ITEM FOR ENVIRONMENTAL COMMISSION AGENDA

COMMISSION MEETING DATE:	October 5, 2022
NAME & NUMBER OF PROJECT:	Park 290 Logistic, SP-2021-0095C
NAME OF APPLICANT OR ORGANIZATION:	BSREP III Decker Lane
LOCATION:	11653 Decker Lane Austin Tx 78724
COUNCIL DISTRICT:	District 1
ENVIRONMENTAL REVIEW STAFF:	Enrique A Maiz-Torres, Environmental Review Specialist Senior, DSD, 512-974-3035
WATERSHED:	Gilleland Creek/Decker Creek, Suburban, Desired Development Zone
R EQUEST:	Variance request is as follows: -Request to vary from LDC 25-8-342 to allow fill over 4 feet up to 28 feet. -Request to vary from LDC 25-8-341 to allow cut over 4 feet up to 22 feet
STAFF Recommendation:	Staff recommends this variance, having determine the finding of fact to have been met.
STAFF CONDITION:	 Provide a tree-shaded outdoor seating area as to encourage employees to take breaks on-site, rather than driving to alternative locations. Provide an on-site trail with drainage swales that naturally convey flows into existing on-site ponds. Provide vegetative walls adjacent to the critical environmental feature located on the site. Provide terraced landscaping area in the open space allocated on the site.

Project Name:

CUT/FILL EXHIBIT

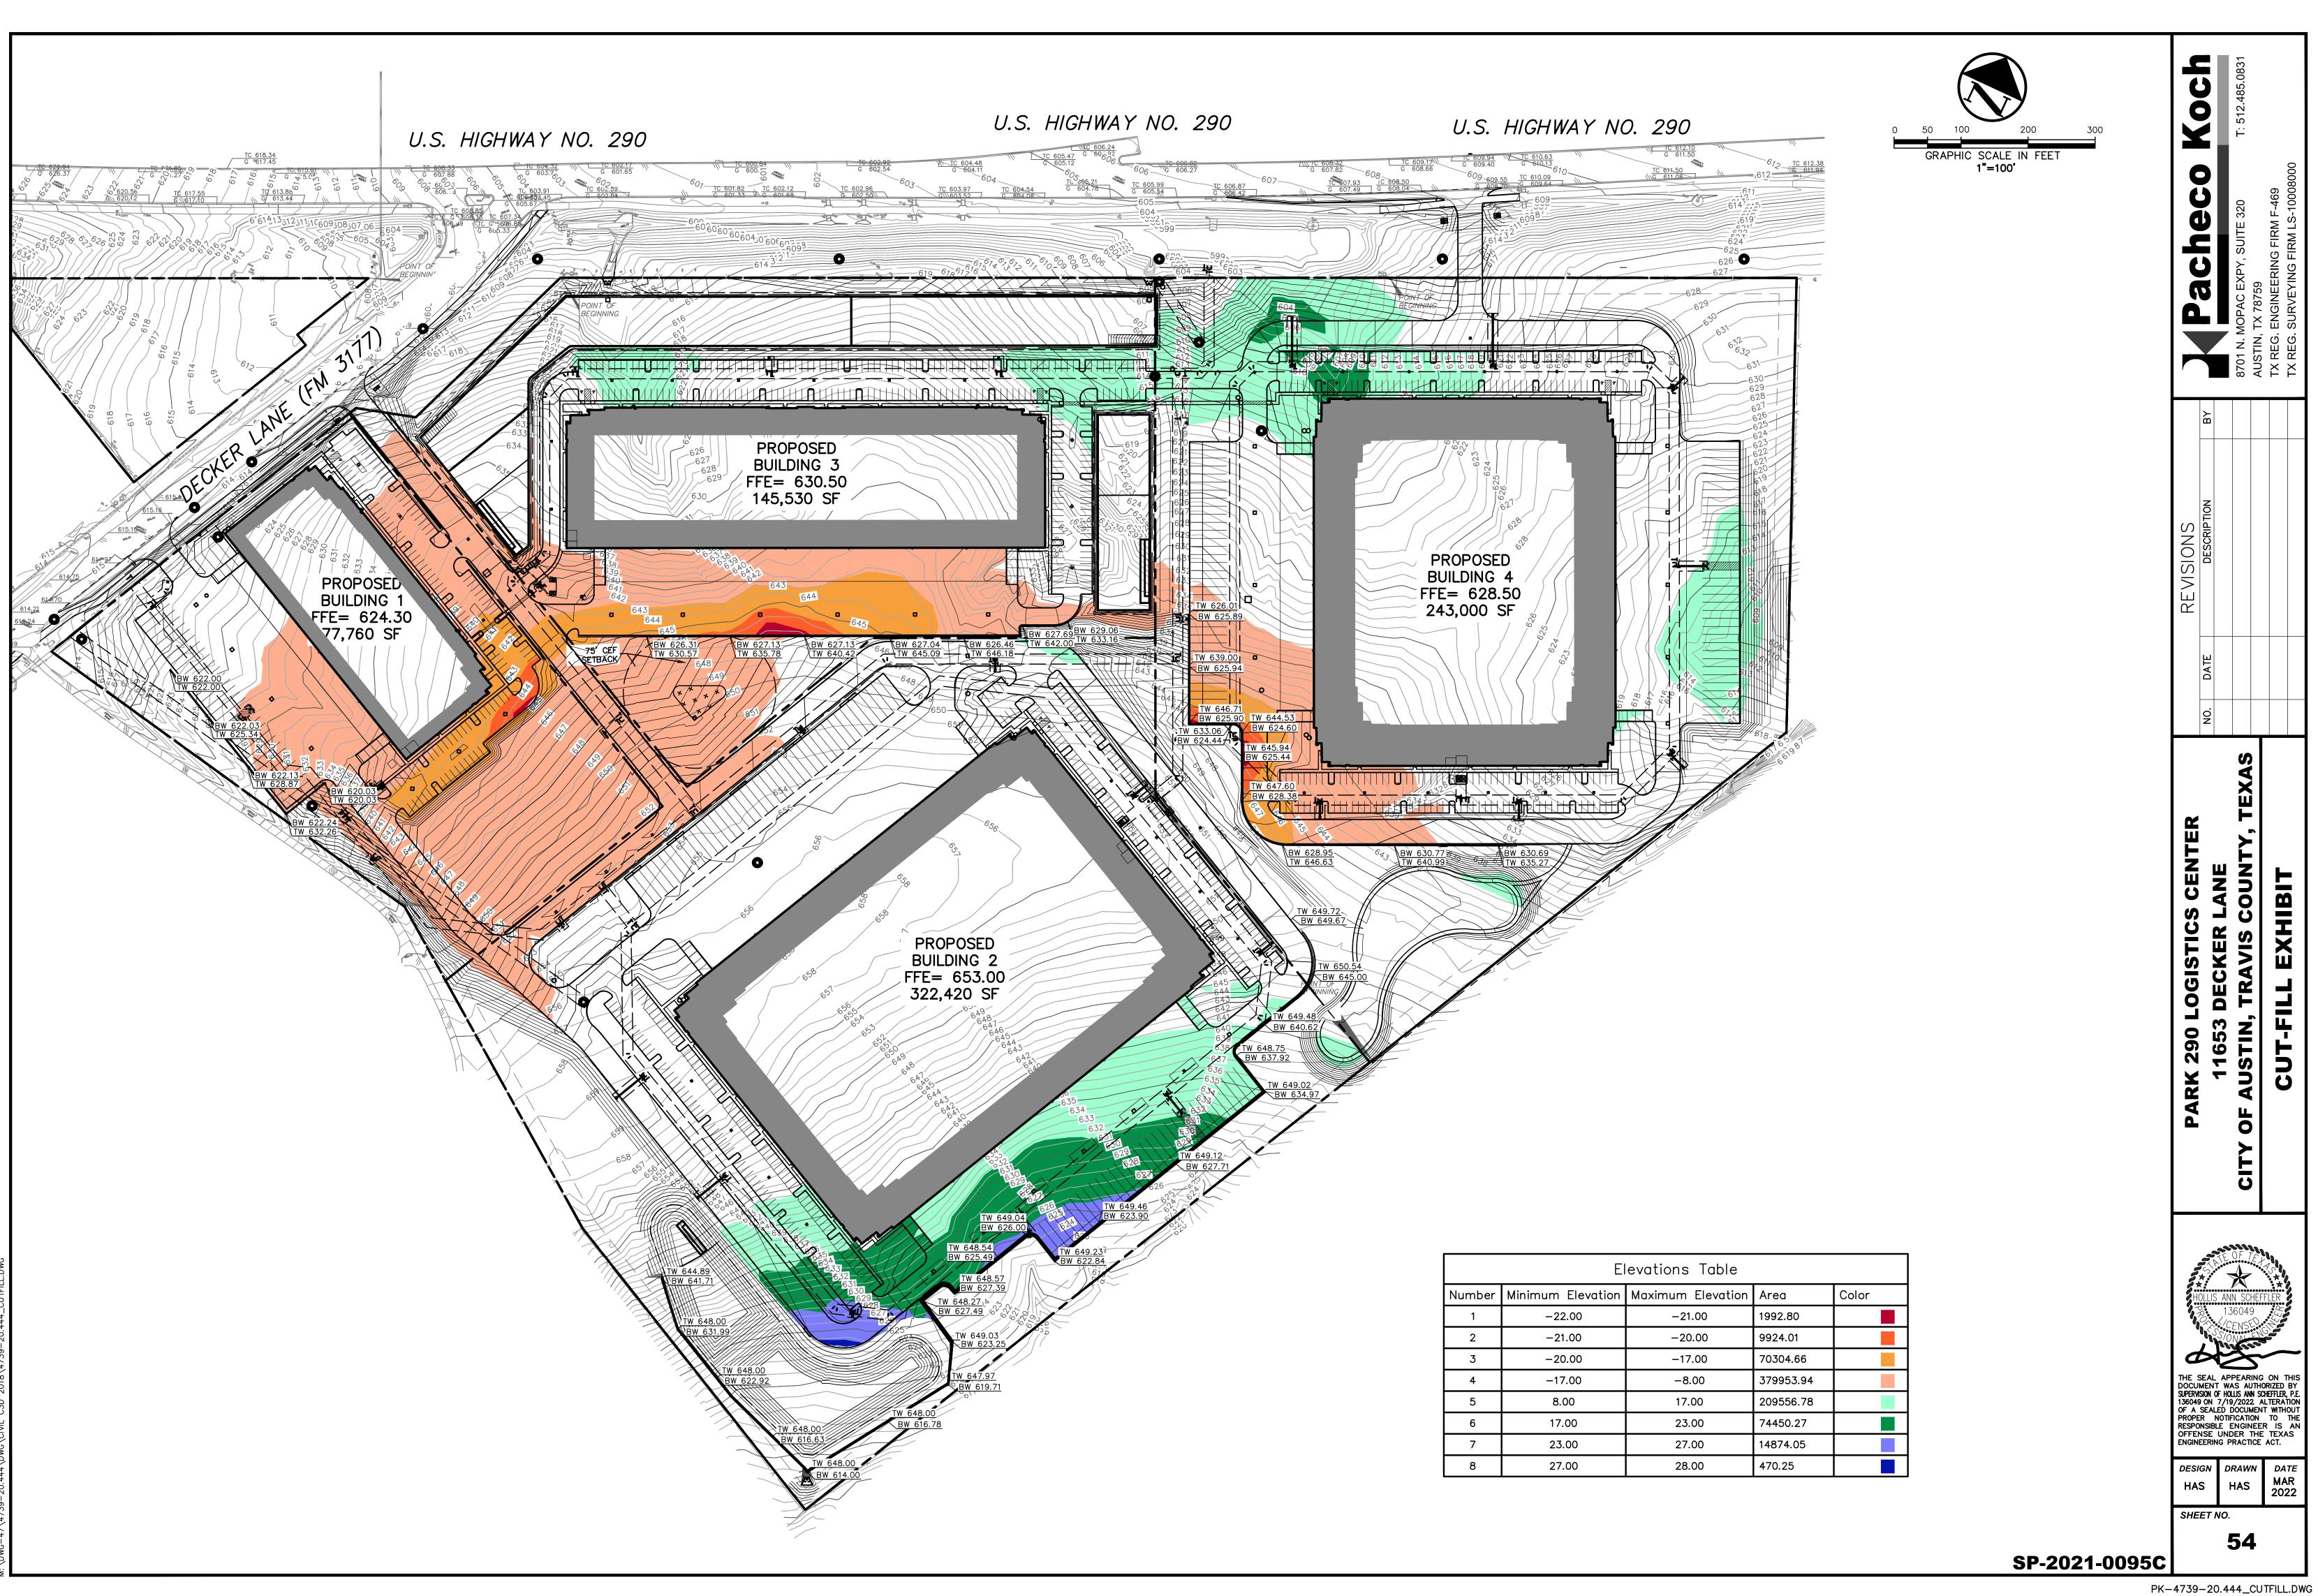
Construction of the Park 290 Logistics center project will require areas of cut and
Clearly indicate in	fill exceeding four (4) feet. Cut between 8' and 21.76' will be limited to mostly
what way the	the internal area between buildings 1, 3, and 4. the This area is 10.62 acres,
proposed project	which is 16.02 percent of the gross site area. Pockets of cut between 4' to 8'
does not comply	throughout the site, the total area is 5.97 acres which is 9.4 percent of the gross
with current Code	site area. Fill between 8' and 27.90' mainly borders building 2 and 3. The total
(include maps and	area is 7.35 acres, 11.09 percent of gross site area. Limited areas of fill between
exhibits)	4' to 8' border the higher sections of fill around building 3 and 4. This total area
	is 1.5 acres, 2.3 percent of the gross site area.
